**BOROUGH OF HIGHLANDS
LAND USE BOARD MEETING**
151 Navesink Ave. - Court Room
Thursday, July 11, 2024 at 7:00 PM

Re: Completeness Review No. 4
Applicant: Kirsh Kraft, LLC
Nine 5th Street
Block 57, Lots 8 & 9
Borough of Highlands, Monmouth County, New Jersey
Our File No.: HLPB2022-04

MINOR SUBDIVISION PLAN
LOTS 8 & 9, BLOCK 57
BOROUGH OF HIGHLANDS MONMOUTH COUNTY NEW JERSEY
WJ ENGINEERING
PETER P. BENNETT III
N.J. PROFESSIONAL LAND SURVEYOR, LIC. No. 40651

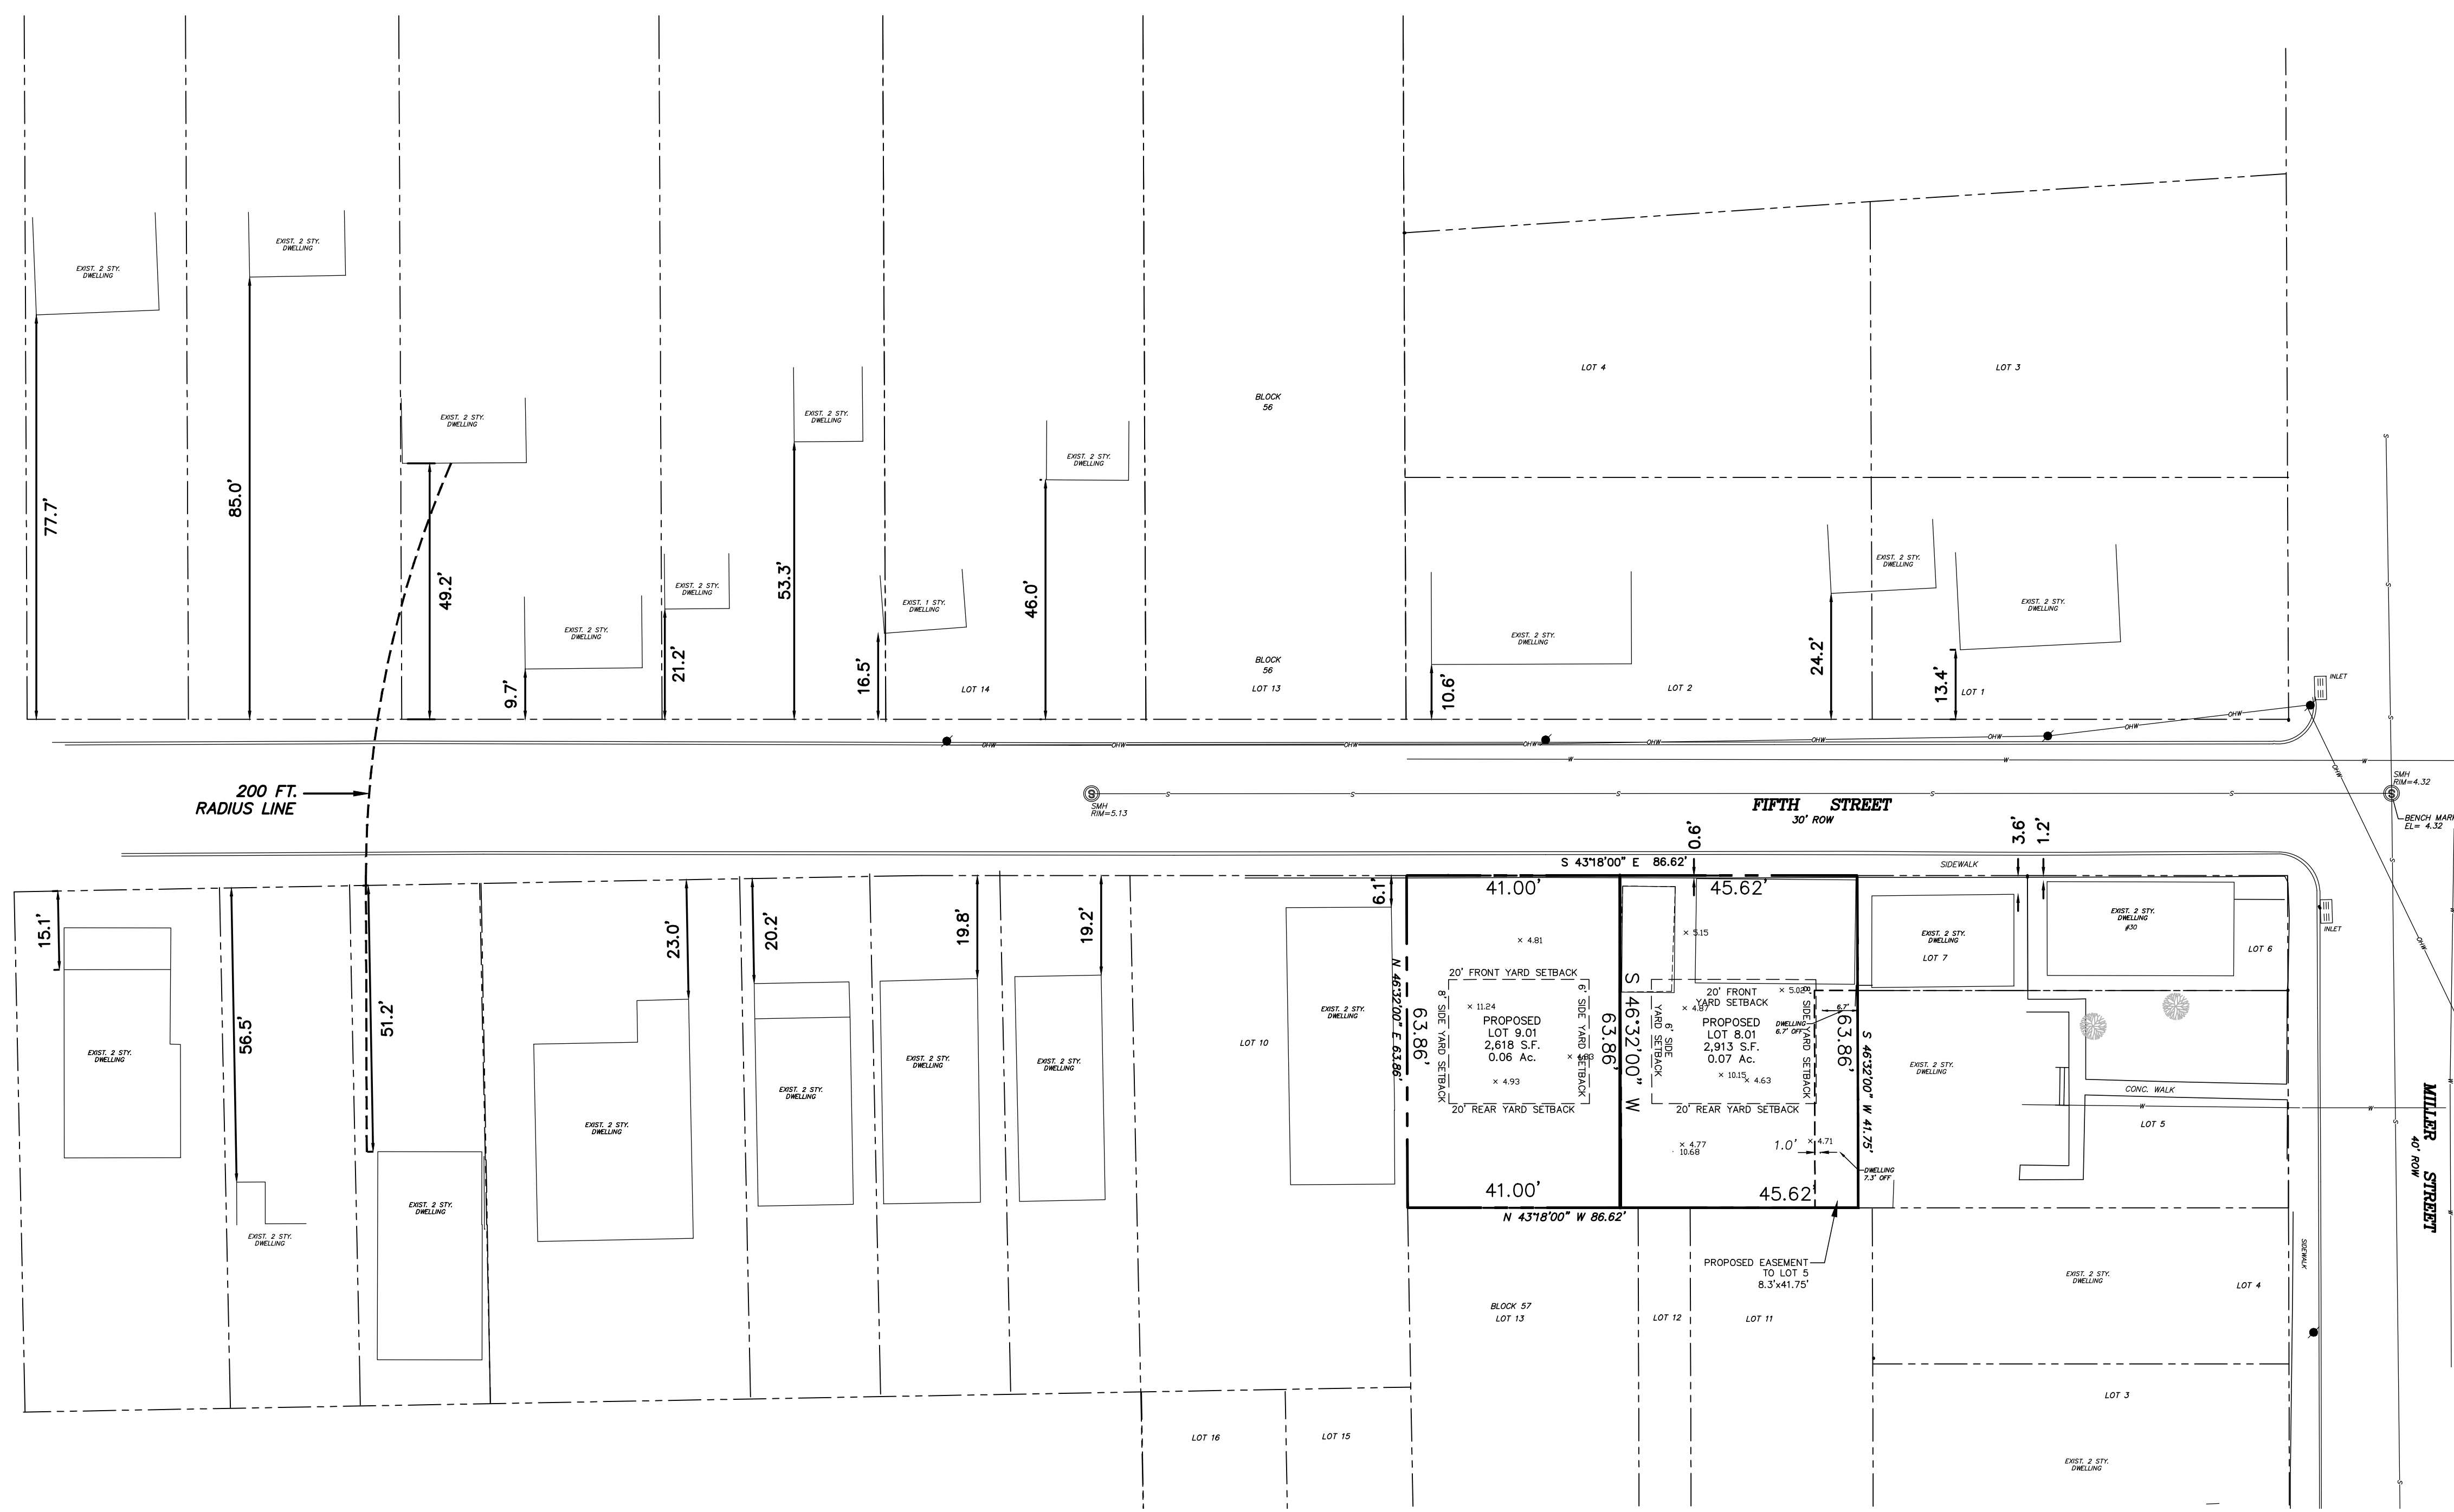
- b. **The Applicant has provided General Note No 8 on the plan and is stated, "Pursuant to NJDEP Geo-Web, no wetlands exist onsite."**

The plan note is incomplete. Please follow the statement provided by Mr. Herrman.

As previously noted, a survey by Seneca Survey Co., Inc. dated August 15, 2016 found that the dwelling on Lot 5 had a maximum encroachment of 1.5-ft. The Minor Subdivision Plan prepared by WJH Engineering, last revised April 5, 2024 indicates a maximum encroachment of approximately 7.2-ft.

DATE: 04-05-2024 SCALE: 1"=10' DRAWN: AJC CHECKED: FF SHEET: 2 OF 8 JOB: PR-0290

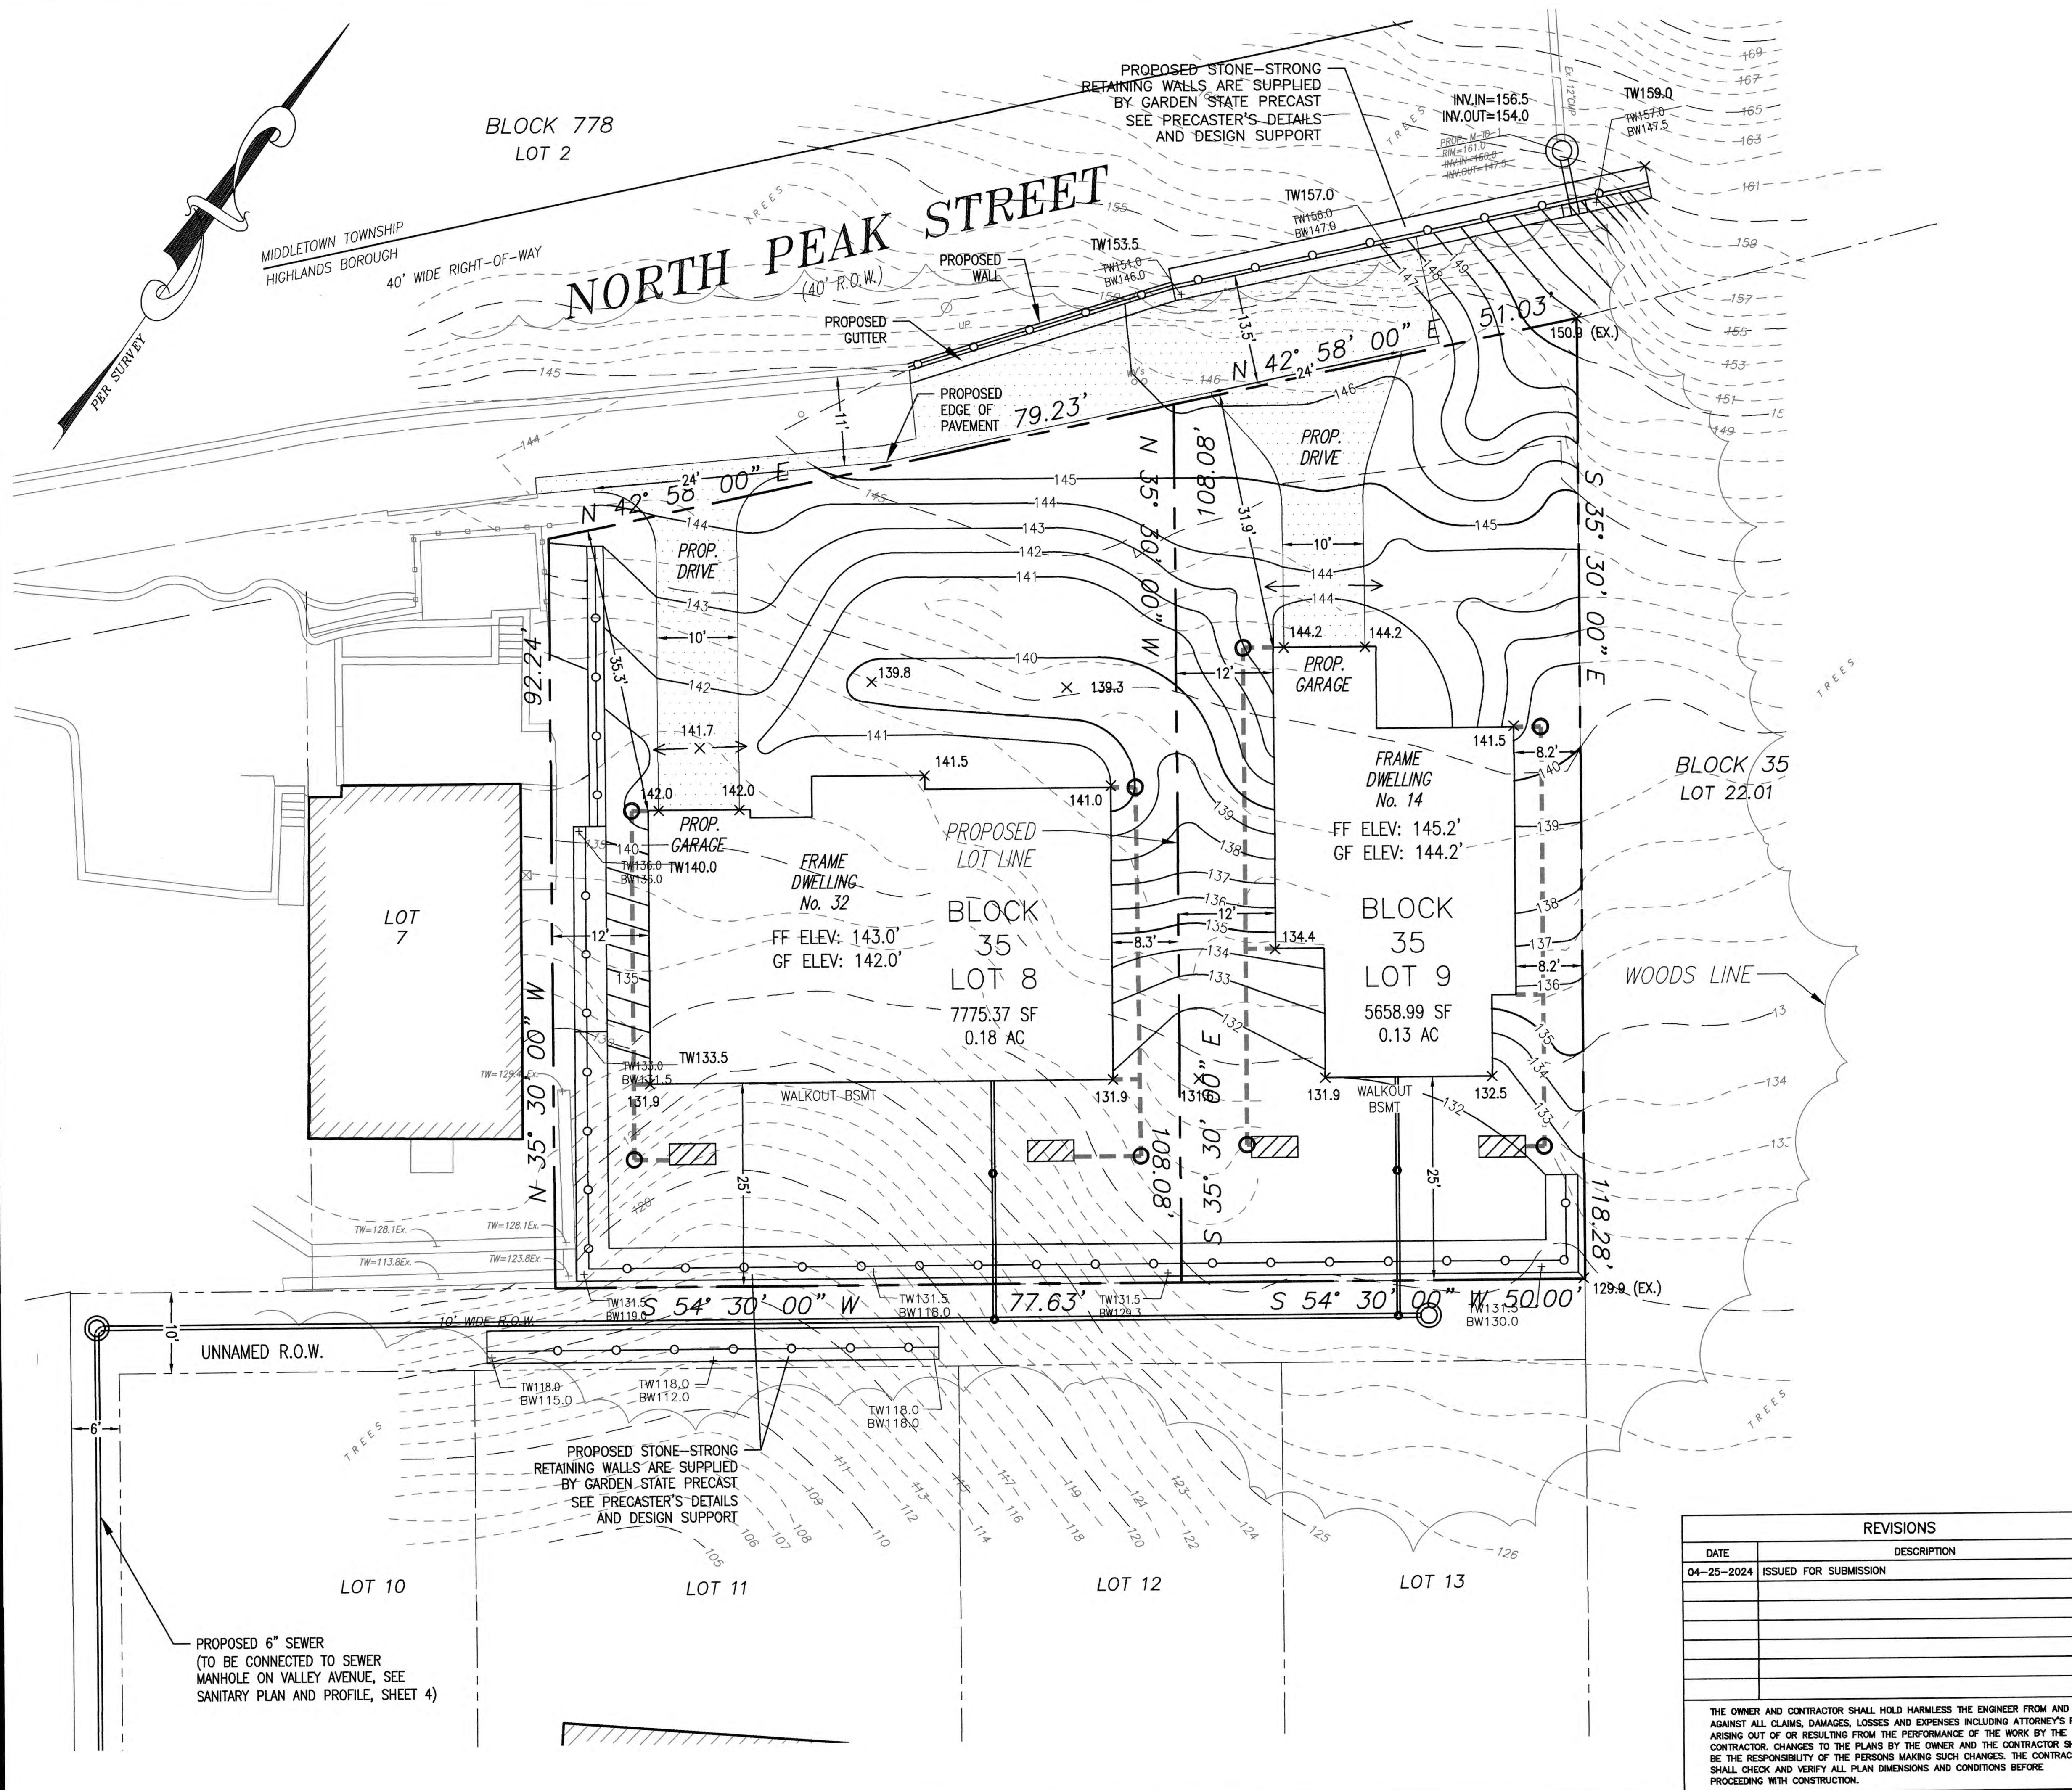
The current purpose of Sheet 2 is unclear and is not as complete as the previous submission.

Sheet 2 indicates the septic tank and one cleanout on existing Lot 9. The disposal bed and service lateral, as part of the system, is requested to be shown. Please provide documentation from the Health Department that the system has been or will be properly removed.
